MESA-BOOGIE
SUBWAY BLUES

SUBWAY BLUES

April 1998

HUM REDUCTION MOD
FOR POTTED CIRCUIT BOARDS

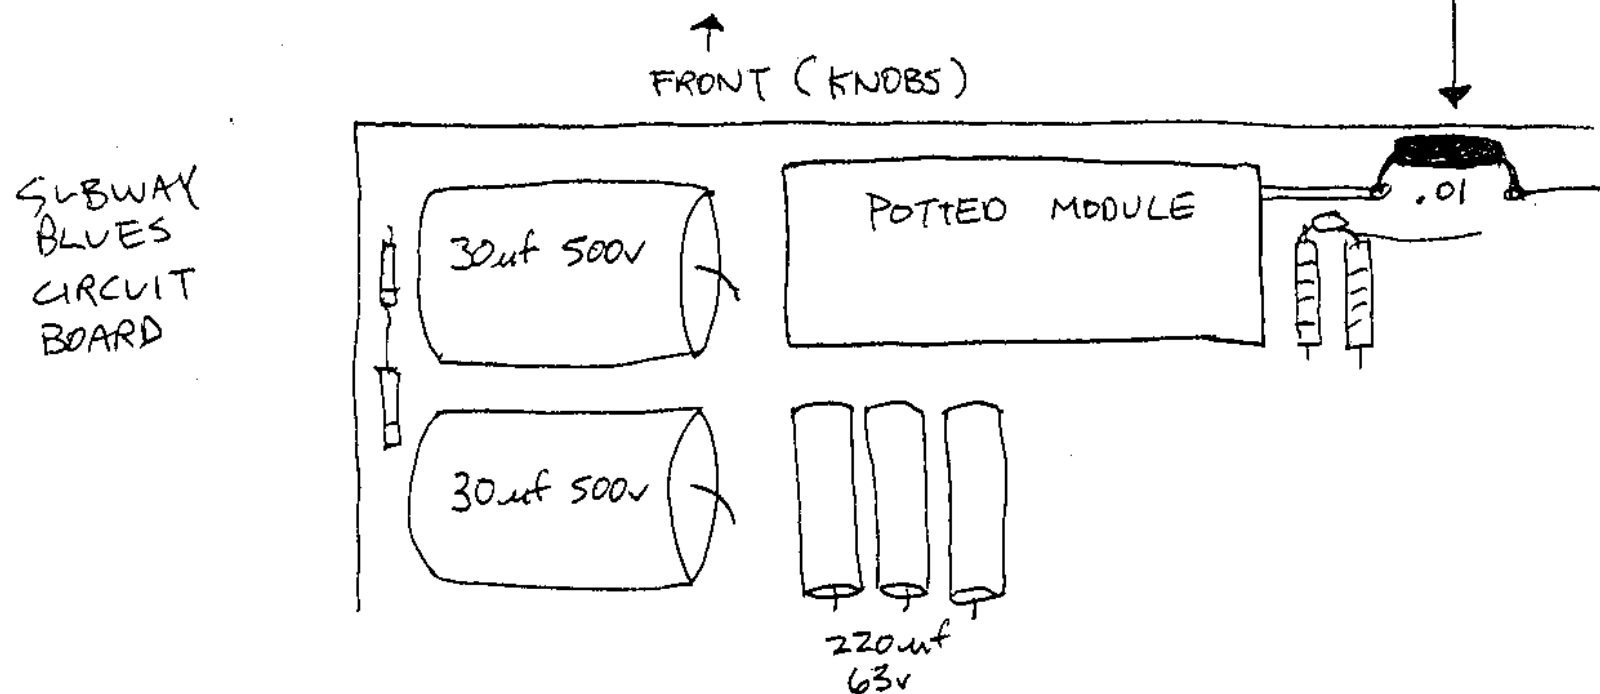
CHANGE THIS CAP (.01)
TO .68/250V

1. Remove orange .01/400v cap from above location
2. Replace with supplied .68/250v cap
